Re: Former Chevron Service Station 95607  
5269 Crow Canyon Road  
Castro Valley, CA  
ACEH Case #RO 0350

Re: Remedial Action Plan Addendum  
Former Chevron Service Station 95607  
5269 Crow Canyon Road  
Castro Valley, California  
ACEH LOP #RO0350

Conestoga-Rovers & Associates (CRA) is submitting this *Remedial Action Plan (RAP) Addendum* (addendum) for the site referenced above (Figure 1) on behalf of Chevron Environmental Management Company (Chevron). This addendum is in response to ACEH's March 15, 2013 letter (Attachment A) and to propose changes to the January 8, 2007 *RAP* submitted by Cambria Environmental Technology (Cambria) and subsequently approved by Alameda County Environmental Health (ACEH) in a February 7, 2007 letter. In the approved *RAP*, Cambria proposed installing a dual-phase extraction (DPE) system to remove hydrocarbon mass in soil and groundwater. The DPE system, as described in the *RAP*, was proposed to be connected to wells C-1, C-3, C-6, C-9, C-12, and RW-1 and would be located in the southern portion of the site. Based on changes to site conditions since it was submitted, CRA proposes the following changes to the approved *RAP*.

**Figure 2**  
**SITE PLAN**  
**FORMER CHEVRON STATION 95607**  
**5269 CROW CANYON ROAD**  
*Castro Valley, California*

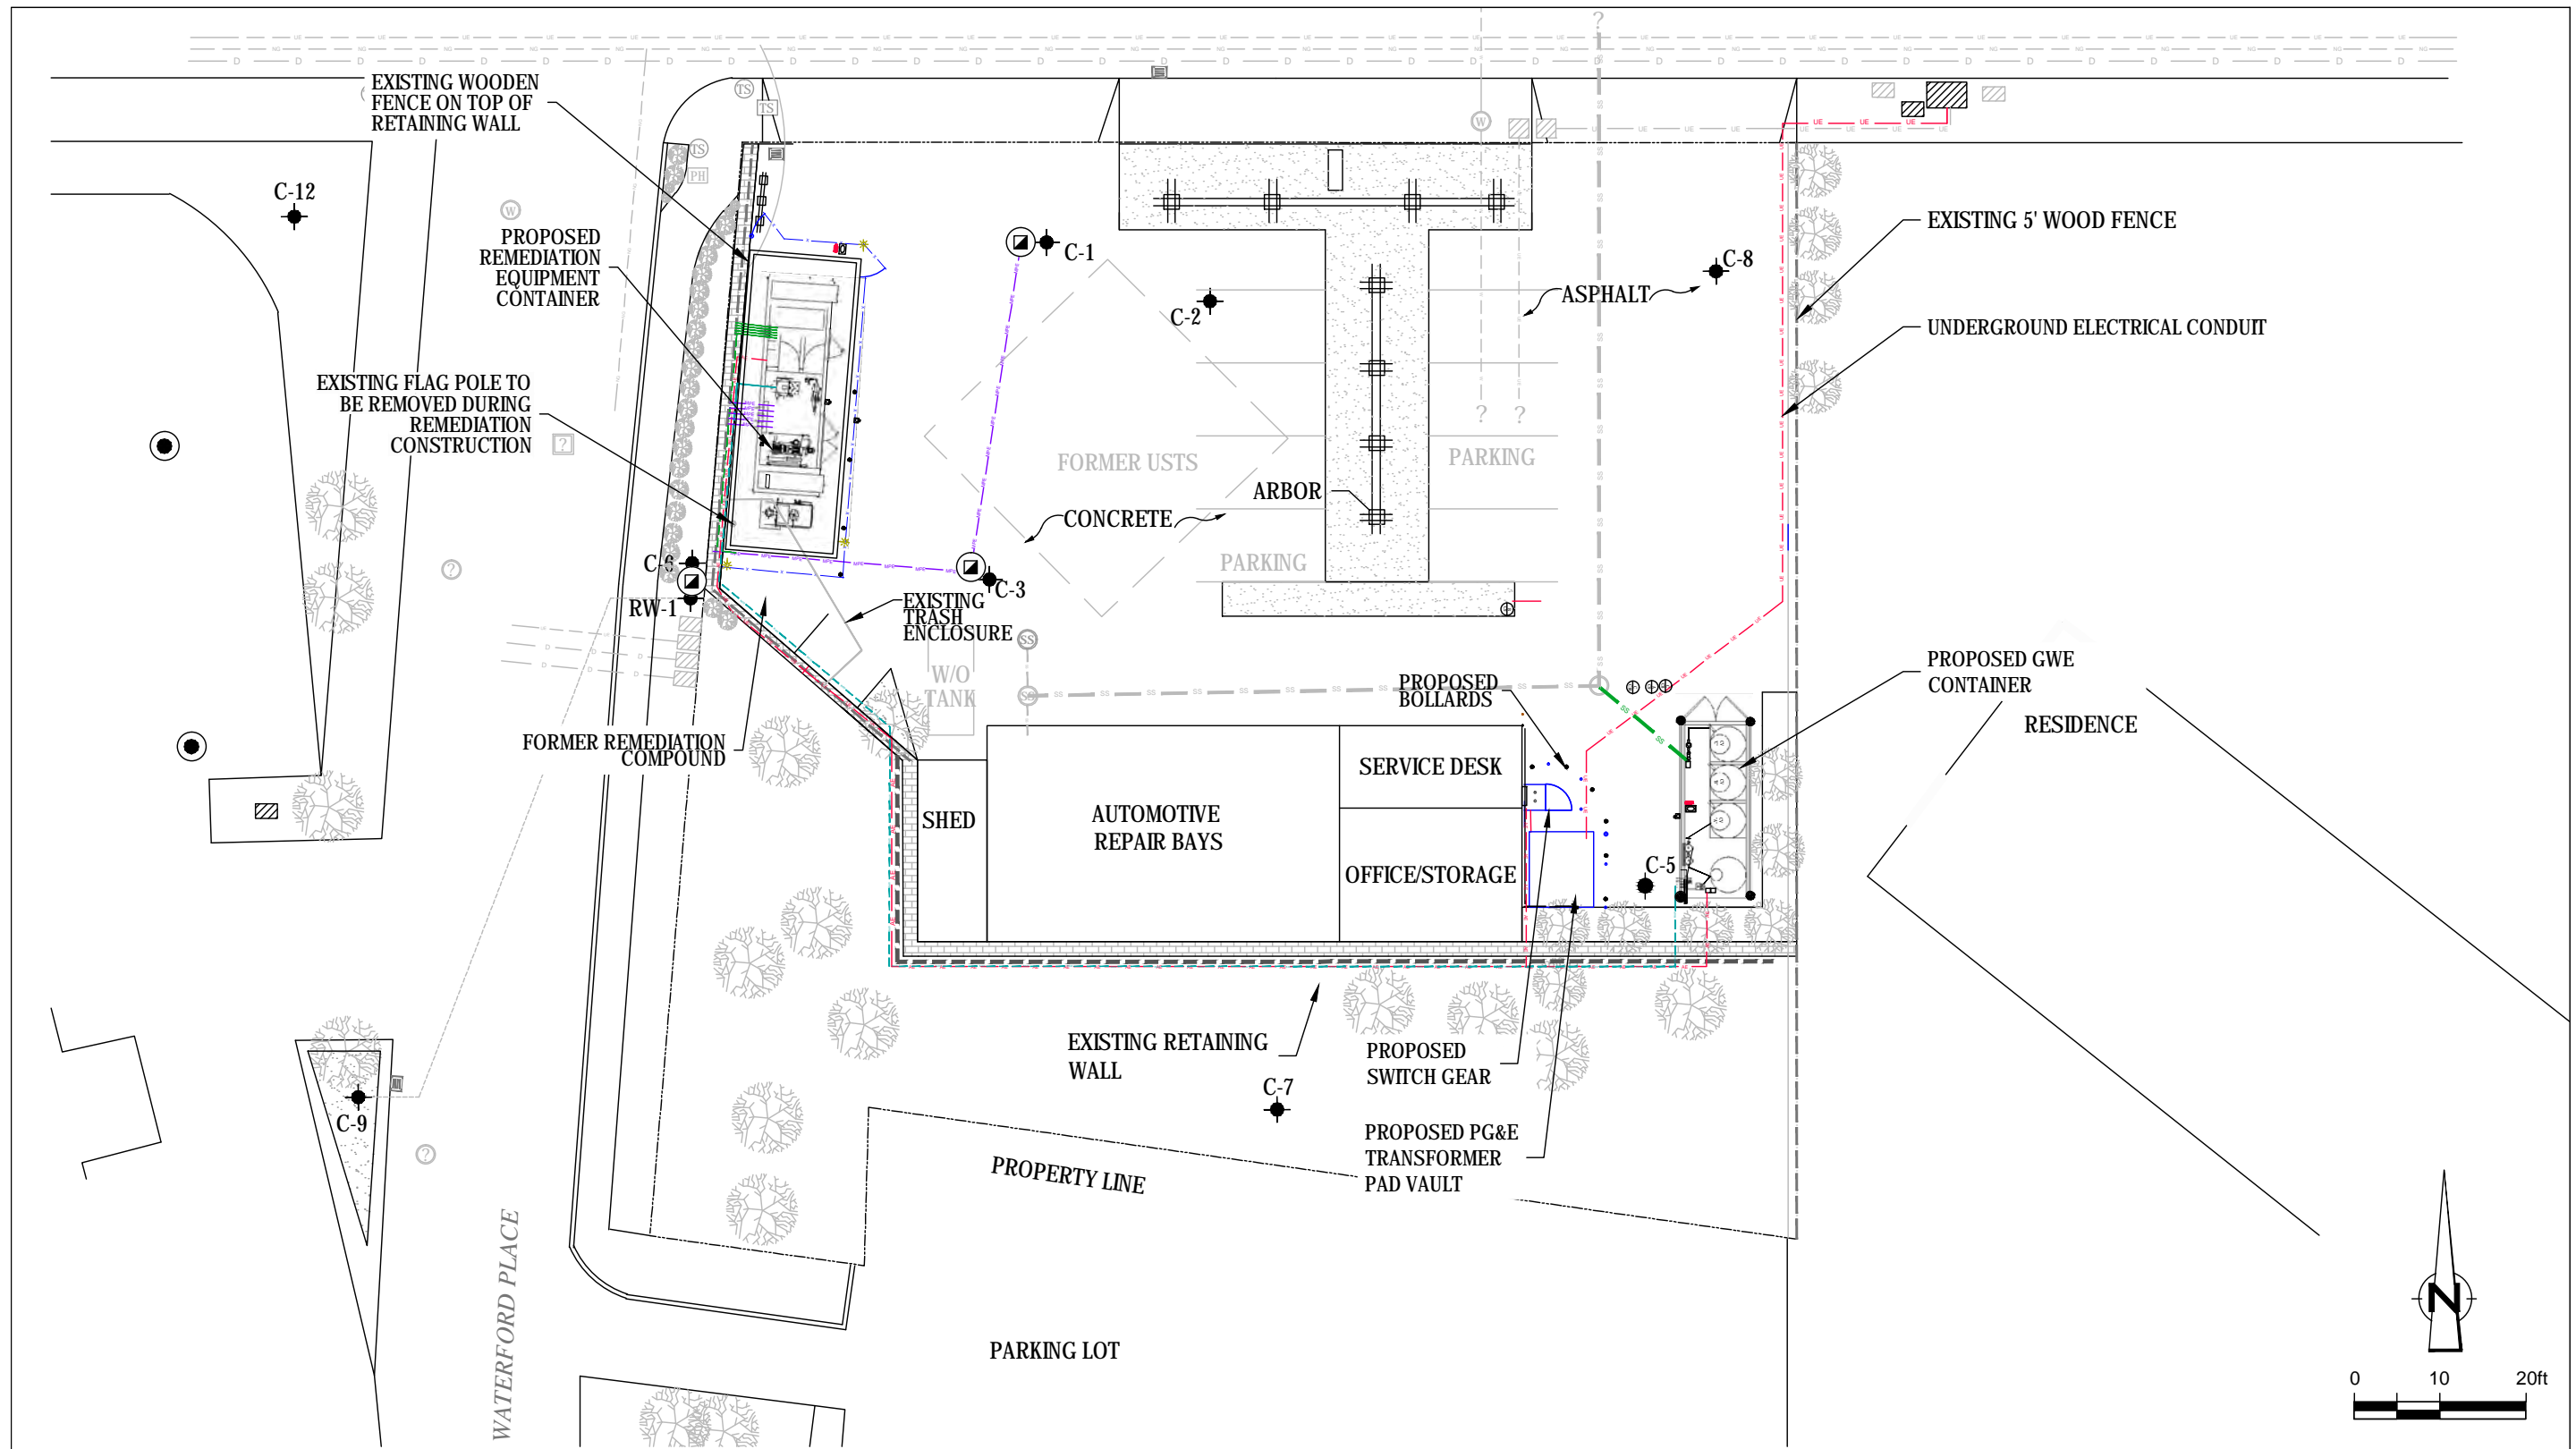
Based upon discussions with the property owner and review of planning ordinances, the location of the system components has been altered. A new electrical transformer will be placed in the southeast corner of the site adjacent to the office. The groundwater treatment enclosure will be placed next to the transformer. The soil vapor extraction enclosure and related equipment will be placed on the western side of the site parallel to Waterford Place (Figure 2). In addition, the retaining wall running parallel to Waterford Place will be reinforced to support the weight of the nearby DPE system components.

As requested by the ACEH in their June 7, 2012 letter, CRA proposed to install an offsite monitoring well between wells C-9 and C-12 for additional offsite horizontal delineation of dissolved hydrocarbons. In response to CRA's August 28, 2012 *Site Conceptual Model and Work Plan* (SCM/WP), ACEH requested that two monitoring wells be installed between C-9 and C-12 in their March 15, 2013 letter. Therefore, CRA proposes to install two offsite monitoring wells between C-9 and C-12 (Figure 2).

- a. **Request for Additional Well** – As noted above the installation of one well has been proposed in lieu of a soil bore transect between wells C-9 and C-12. ACEH is in general agreement with the installation of wells to infill this gap; however, it appears appropriate to install two wells in this coverage gap to help monitor changes in the dissolved groundwater plume downgradient of the proposed remediation activities. This also appears to be appropriate because of the significant spike in groundwater concentration in well C-9 during the January 2013 sampling event (<50 to 8,400 µg/l TPHg, <0.5 to 1,600 µg/l benzene, and <0.5 to 310 µg/l ethylbenzene), and due to potential subsurface complexities related to the apparent presence of unevenly eroded bedrock beneath the site. As a consequence ACEH requests the submittal of a revised Figure 2 to document the proposed well installation adjustments.
